GSI-191/SUMP MEETING BETWEEN NRC AND WESTINGHOUSE ELECTRIC COMPANY ON THE AP1000 DESIGN CERTIFICATION AMENDMENT

September 2, 2009

AP1000 Long-Term Cooling Debris Issues Resolution

SRSB-23; FA Test Report, Reduced Flow

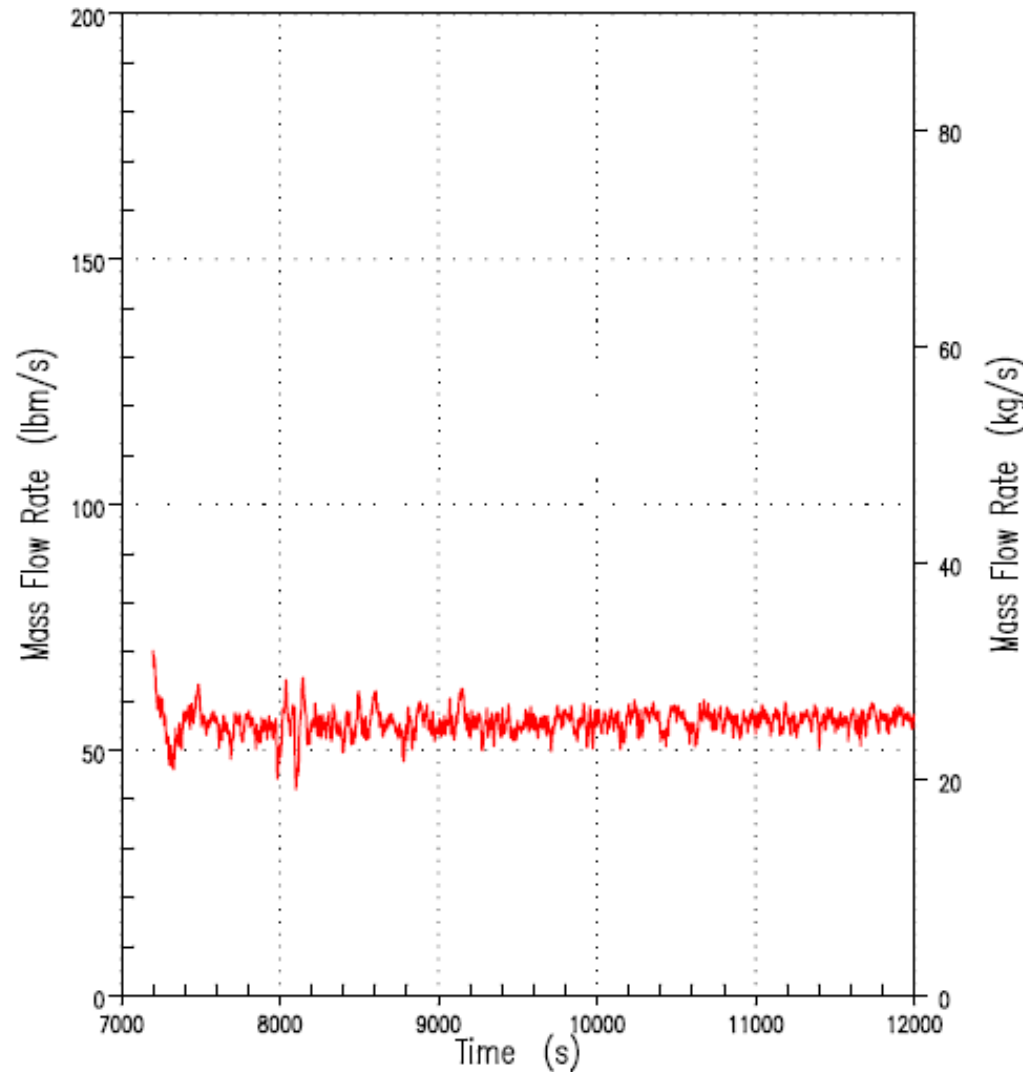
- Why reduce flow for test #16
 - AP1000 has run 3 LTC sensitivity analysis with increasing amounts of assumed head loss across core and screens
 - As head losses were increased the flow rates through the core decreased
 - To be expected since plant operates in natural circulation
 - Different that active plants where flow remains constant as long as pumps have enough NPSH
 - Most FA tests were run with a higher flow rate that was based on clean core / screens with high head loss limit
 - Need to verify head loss at reduced flow used in sensitivity analysis
 - Running test at reduced flow avoids need to extrapolate the test flow / head loss to the sensitivity analysis flow / head loss
 - Eliminates uncertainty

SPCV-21; Flashing Across IRWST Screen

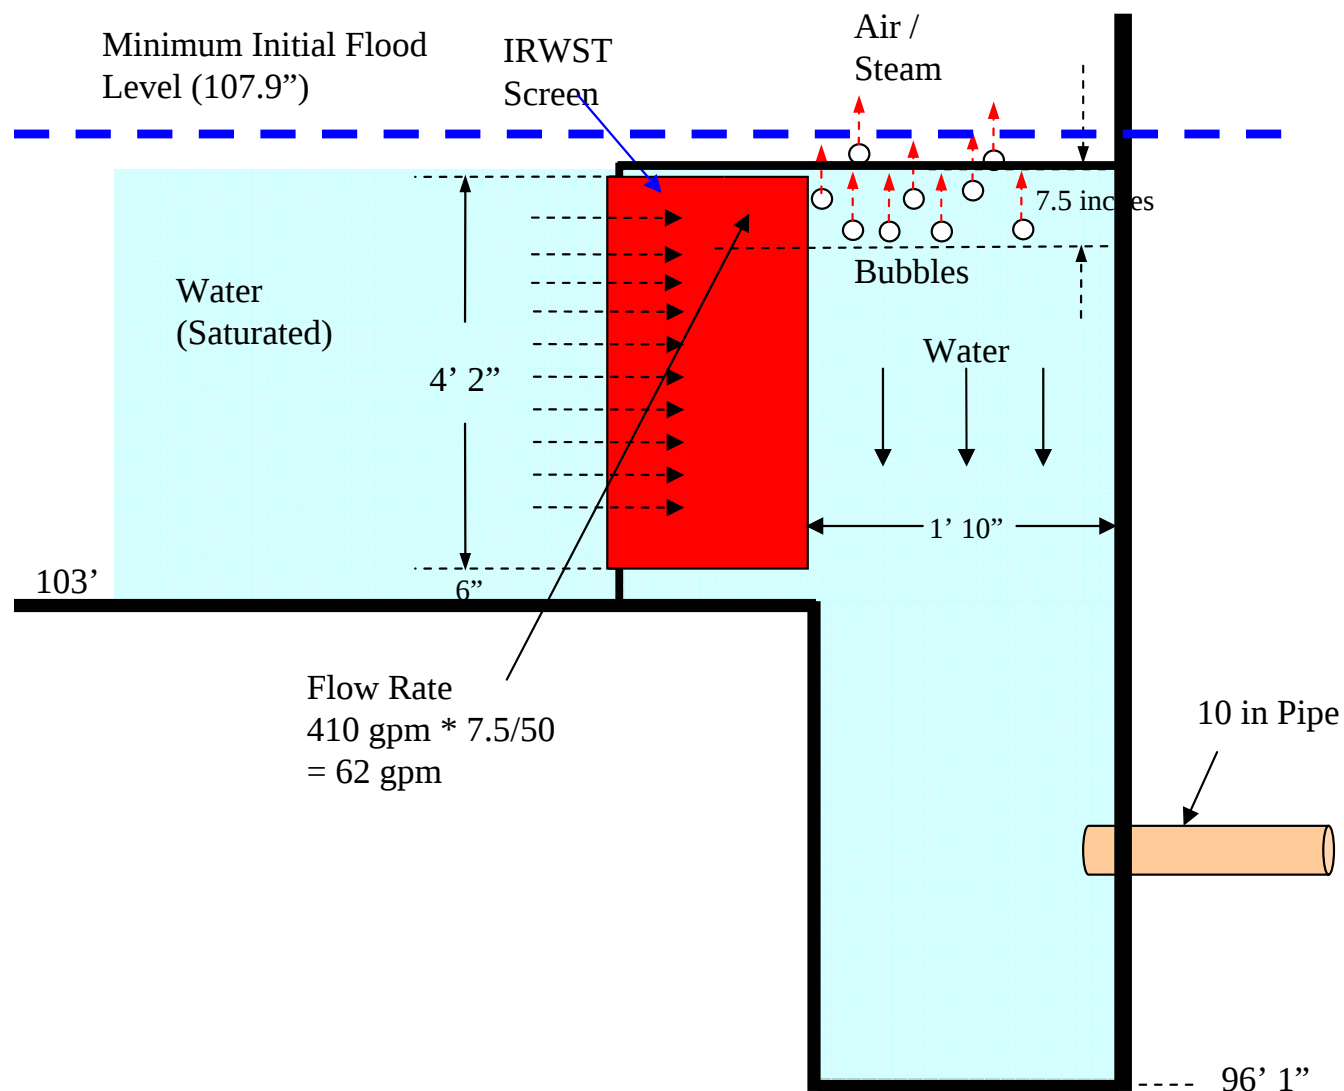
f) Flashing across IRWST screen

- For small LOCAs, there will be extended operation of the PRHR HX prior to the actuation of ADS
 - Will heat up IRWST to saturation
 - In long-term IRWST will become sub-cooled
 - Passive containment steam condensate is sub-cooled 30-40F
- Two limiting saturated water levels are considered
 - One limiting level is just above top of screen such that water seals screen from IRWST gas space
 - Flashing could occur across screen
 - Another limiting case is a slightly lower level when water no longer seals off IRWST gas space
 - Flashing will no longer occur
 - Min initial recirc level will be at 107.9', about 2.8" above top screen

SPCV-21; Flashing Across IRWST Screen

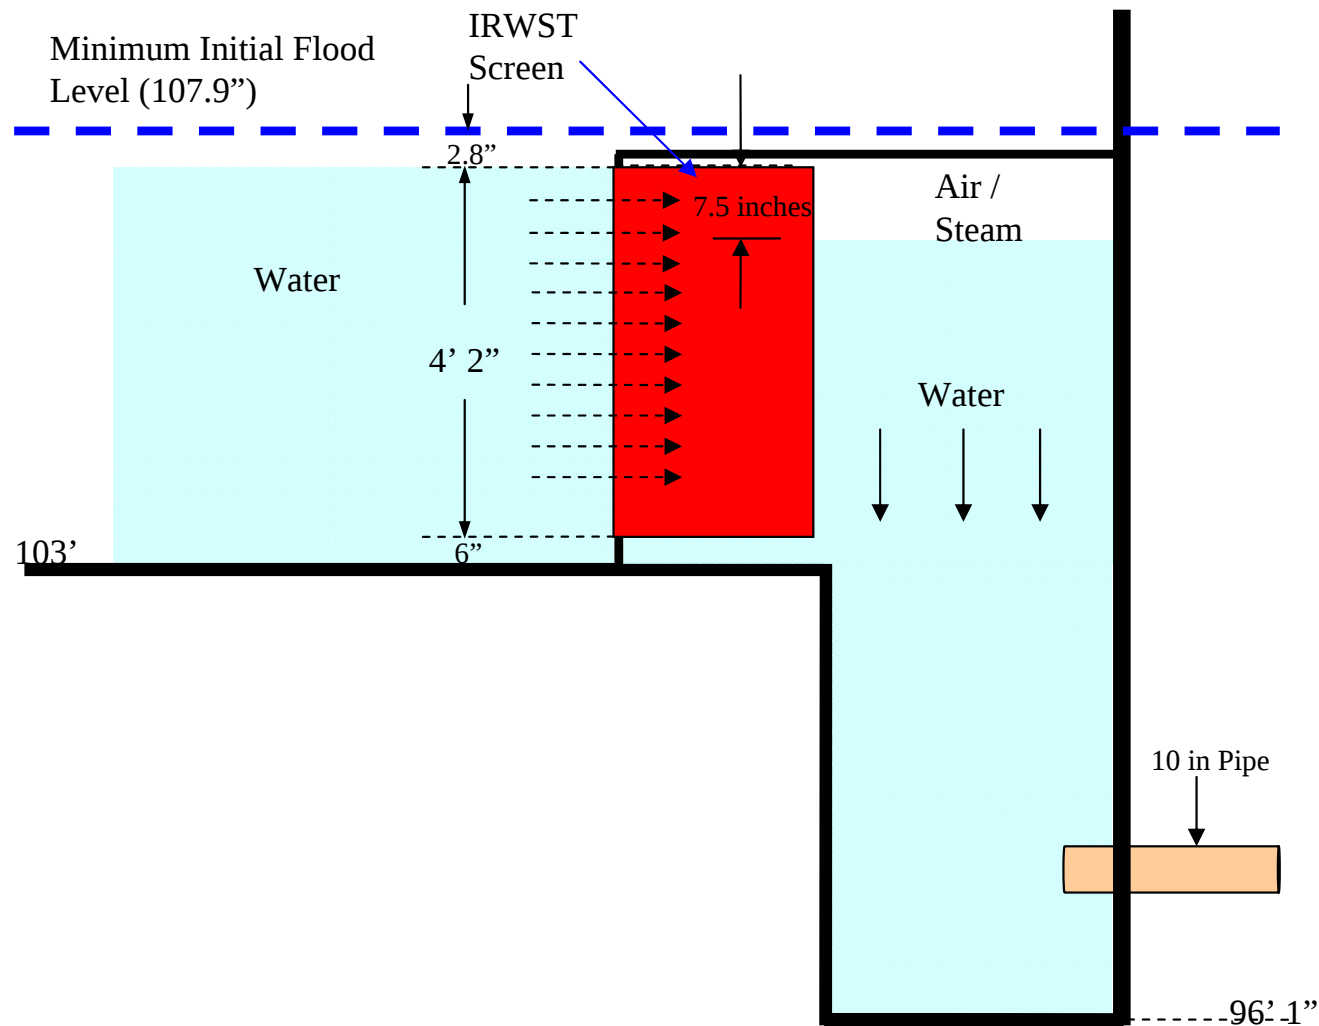
- Flashing across IRWST screen
 - The steam bubble rise velocity and the water down flow velocities are calculated and compared
 - Steam bubble rise is calc based on
 - Lowest level where bubbles can occur is 7.5" below the top of the screen based on max head loss across screen.
 - The water level is at the top of the IRWST screen.
 - Steam bubble diameter is 1/16" (hole ID through screen)
 - Calc steam bubble rise velocity ($> 15\text{cm/s}$) is much higher than the water down flow velocity (0.3 cm/s) such that the bubbles will not be entrained into the PXS injection flow
